Shenzhen ADDX Innovation Technology co., LTD.
NO. 2902, Building 9A-1. Shenzhen Bay Technology and Ecological Park, Nanshan District,
Shenzhen, China
TEL: 18594279025

Class II Permissive Change Letter

FCC ID Certification No.: 2AUDF-CG62X

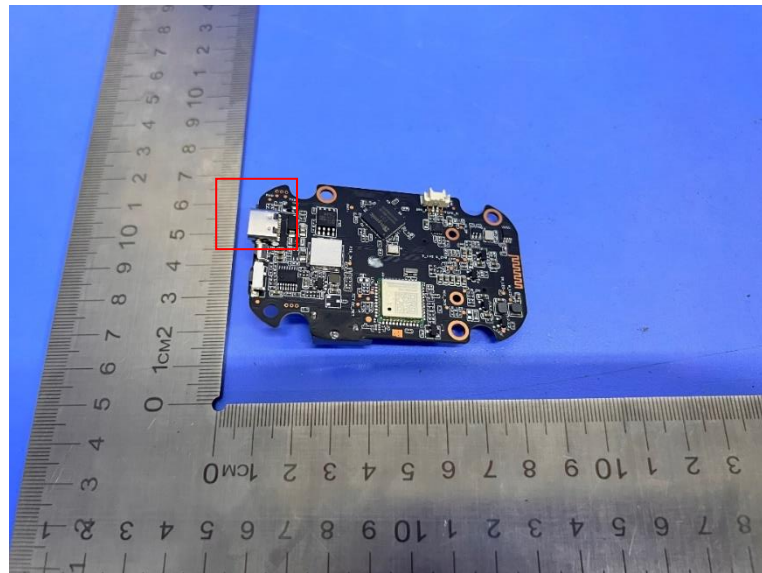
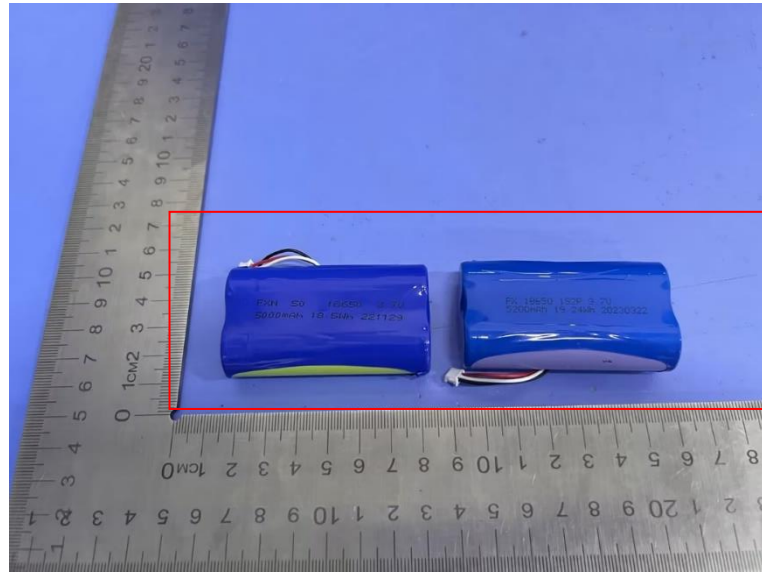
1. Battery capacity increases
2. Charging port is changed to type-c
